Entergy Nuclear Operations, Inc.
Pilgrim Station
600 Rocky Hill Road
Plymouth, MA 02360

SUBJECT: Entergy Nuclear Operations, Inc.
Pilgrim Nuclear Power Station
Docket No. 50-293 License No. DPR-35
License Renewal Application Amendment 8

LETTER NUMBER: 2.06.081

**Response to Requests for Additional Information (RAIs) on LRA Section
2.4 Scoping and Screening Results: Structures**

The simplified drawings on the following two pages depict the Pilgrim refueling cavity seal components.

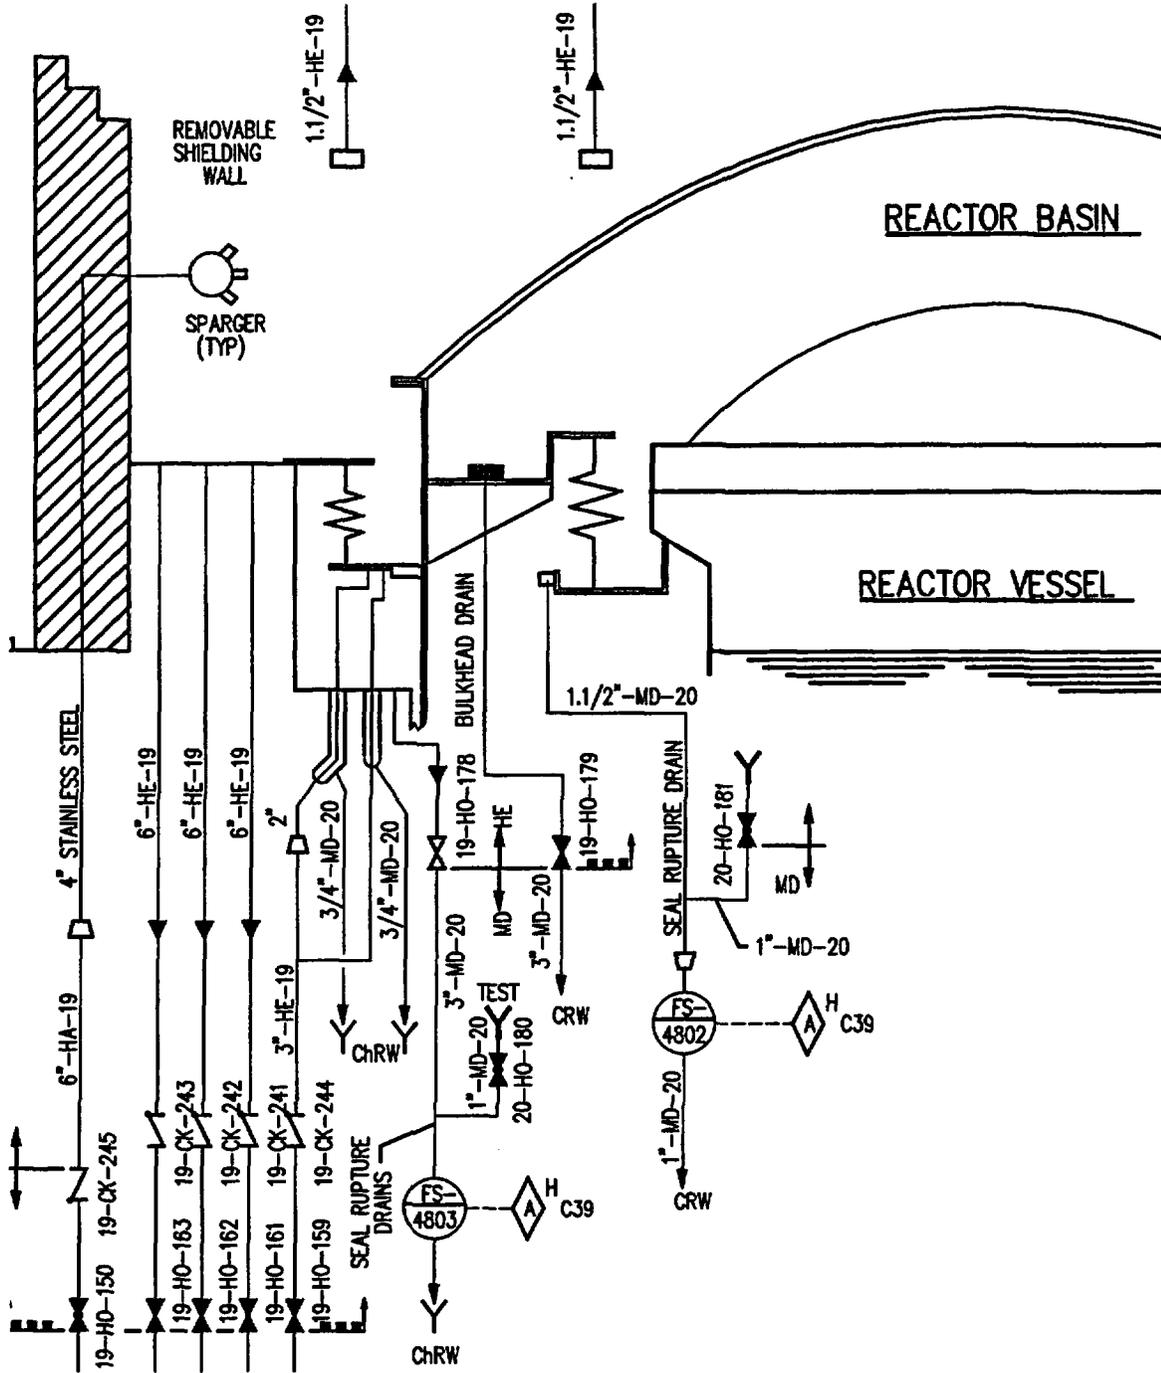
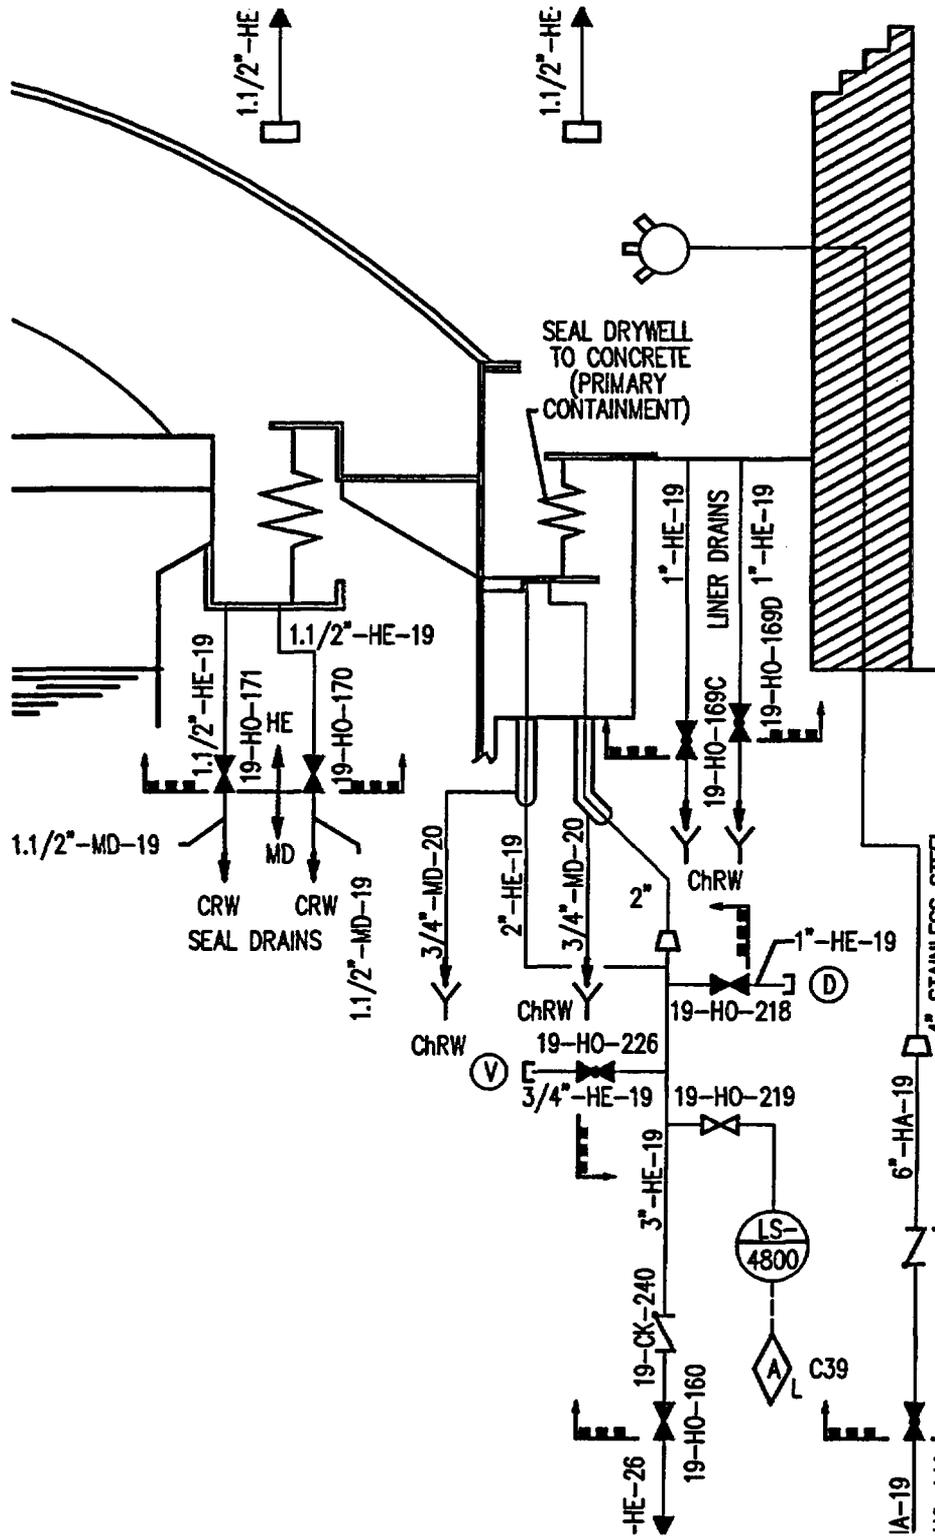
Neither Table 2.4-1, Primary Containment, nor Table 2.4-2, Reactor Building, of the LRA incorporates refueling cavity seal components within the scope of license renewal. The proposed license renewal interim staff guidance LR-ISG-2006-01, "Plant Specific Aging Management Program for Inaccessible Areas of Boiling Water Reactor Mark 1 Steel Containment Drywell Shell," which was published in the Federal Register on May 9, 2006, stated that the most likely cause of corrosion of the drywell shell in the sand-pocket areas (near the bottom of the drywell), and in the spherical portion of the drywell at higher elevations, was the water in the gap between the drywell and the concrete shield, and the source of the water was noted as leakage through the seal between the drywell and the refueling cavity. Therefore, the staff requests the applicant include all the refueling cavity seal components within the scope of license renewal and provide a drawing that depicts the refueling cavity seal components.

Proposed license renewal interim staff guidance LR-ISG-2006-01, "Plant Specific Aging Management Program for Inaccessible Areas of Boiling Water Reactor Mark 1 Steel Containment Drywell Shell," which was published in the Federal Register on May 9, 2006, states, if moisture has been detected or suspected in the inaccessible area on the exterior of the drywell shell, include in the scope of license renewal any components that are identified as a source of moisture, such as the refueling seal, and perform an aging management review. As stated in Amendment 1 to the PNPS LRA¹, there has been no observed leakage causing moisture in the vicinity of the sand cushion at PNPS and no moisture has been detected or is suspected on the inaccessible areas of the drywell shell. Therefore, consistent with the draft ISG, the refueling seal is not subject to aging management review. In response to staff questions during the site audit, PNPS confirmed that refueling cavity seal components do not perform a license renewal intended function and are not subject to aging management review.
